City of Ferndale  
Addendum 1  
LEGOE AND WASHINGTON  
INTERSECTION IMPROVEMENTS  
PROJECT  
ST 2013-03

**ADDENDUM 1**

**LEGOE AND WASHINGTON INTERSECTION IMPROVEMENTS PROJECT  
ST 2013-03**

**ADDENDUM NO. 1**  
**To the Contract Provisions for**  
**CITY OF FERNDAL, WASHINGTON**

DWG DEMO AND TESC PLAN		DATE
JOB#	SCALE	SHEET
13041	H:1"=20' v: N.A.	004

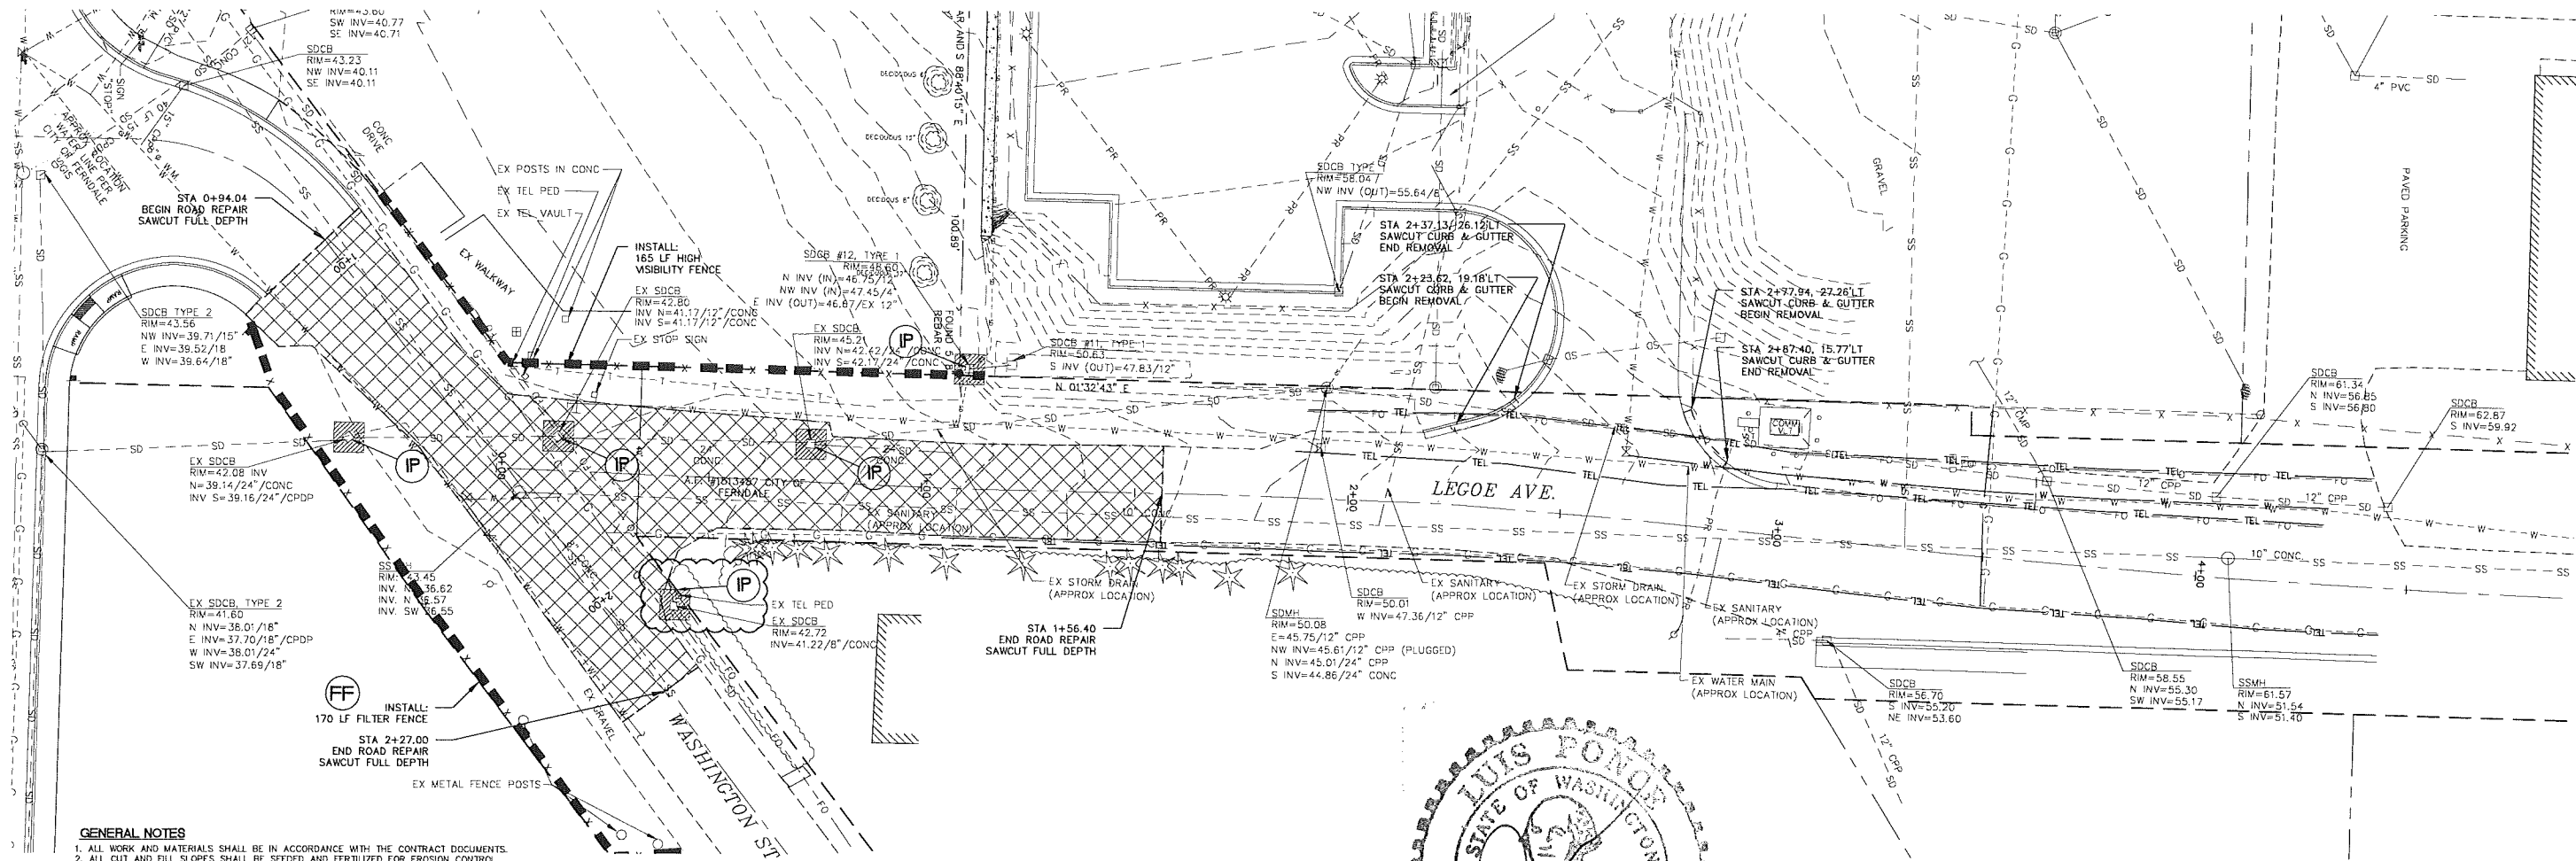
The attached Plan Sheet 004 shall replace Plan Sheet 004 dated 10/18/13. The existing SDCB located at approximately STA 2+12, 14'R shall receive inlet protection.

DWG SITE AND GRADING PLAN		DATE
JOB#	SCALE	10/18/13
13041	H: 1"=20' V: N.A.	SHEET
		005

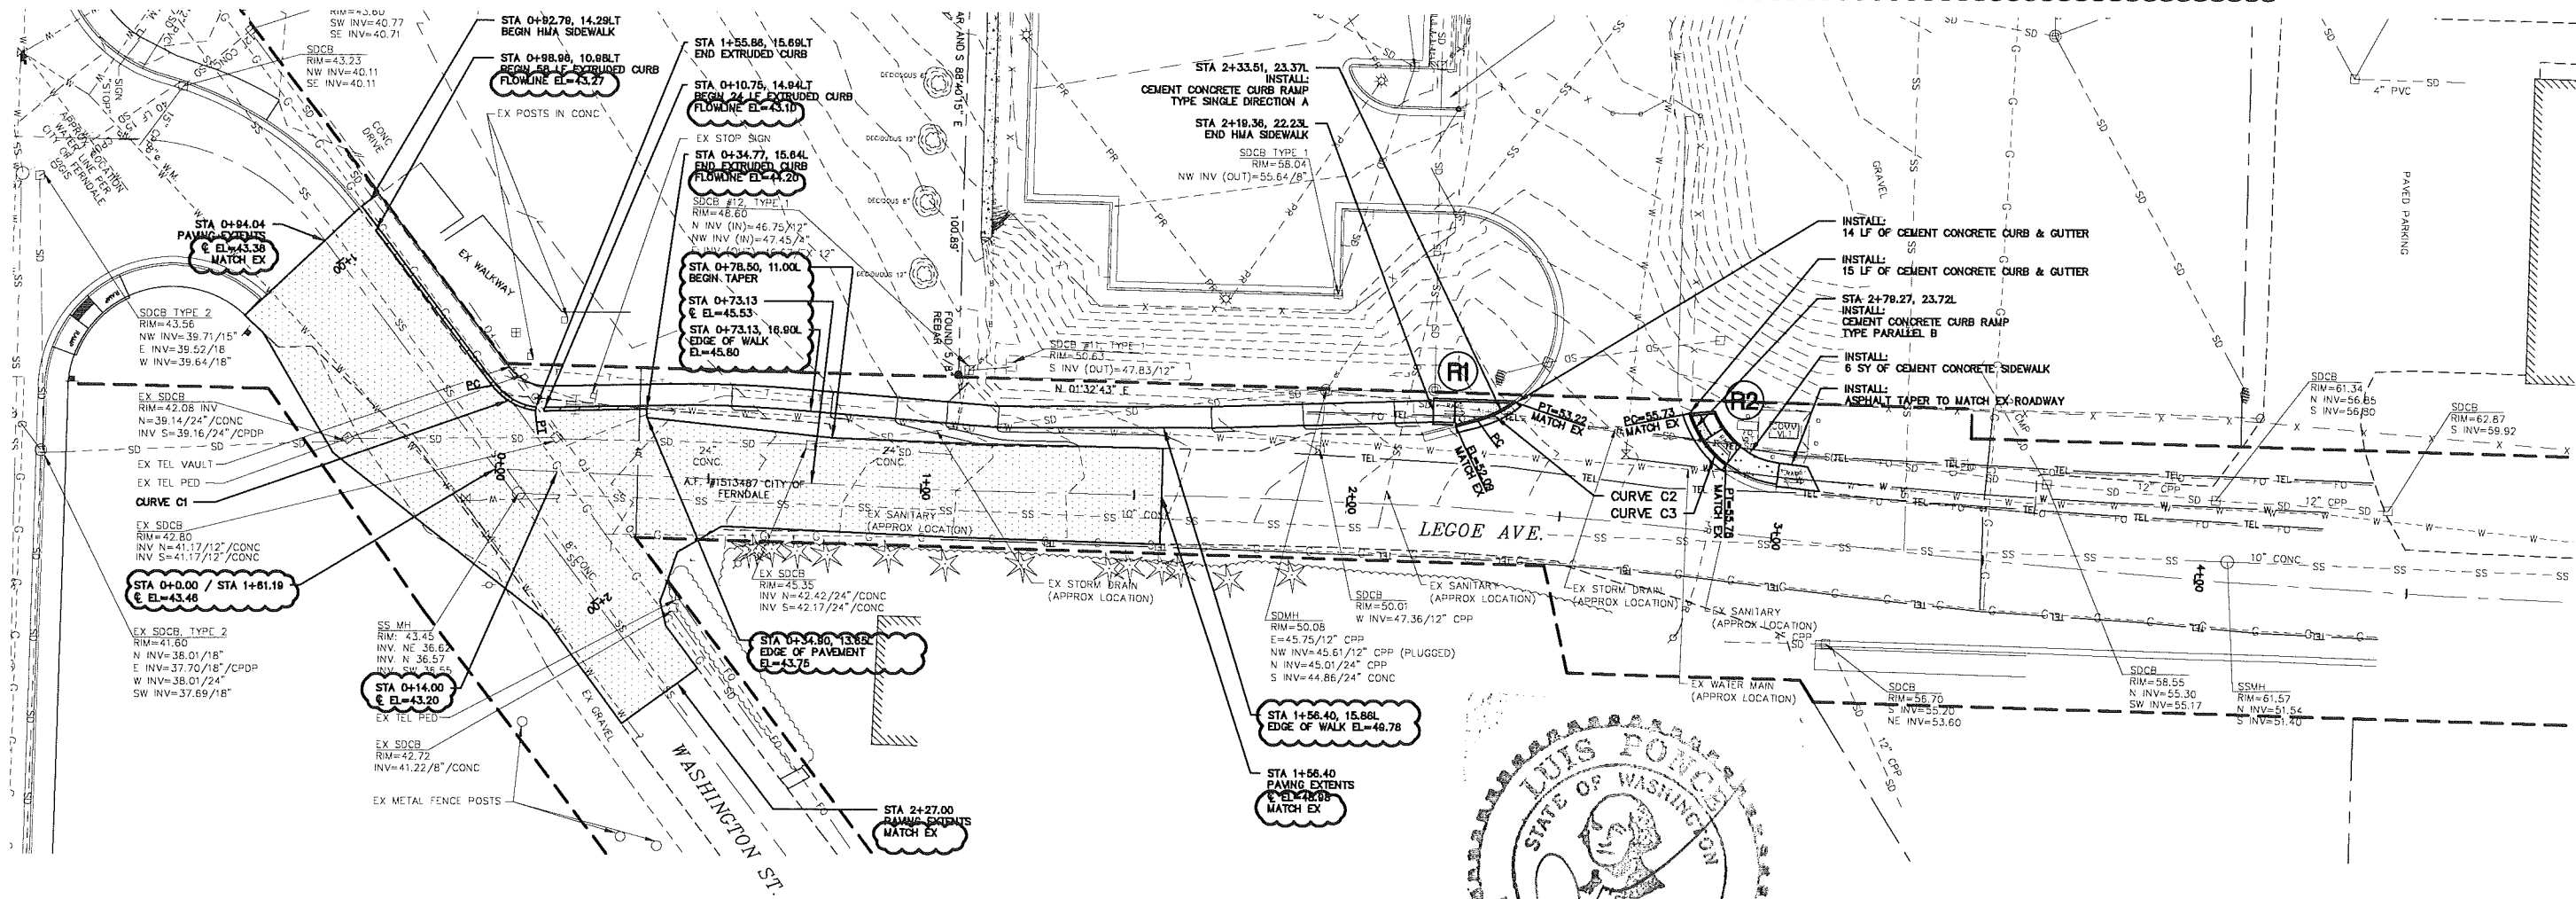
The attached Plan Sheet 005 shall replace the Plan Sheet 005, dated 10/18/13. Spot elevations and flowline elevations were added to the drawing. A note was added indicating storm drain catch basin rim elevations shall remain.

NOTE:  
1. EXISTING STORM DRAIN CATCH BASIN RIM ELEVATIONS SHALL REMAIN.
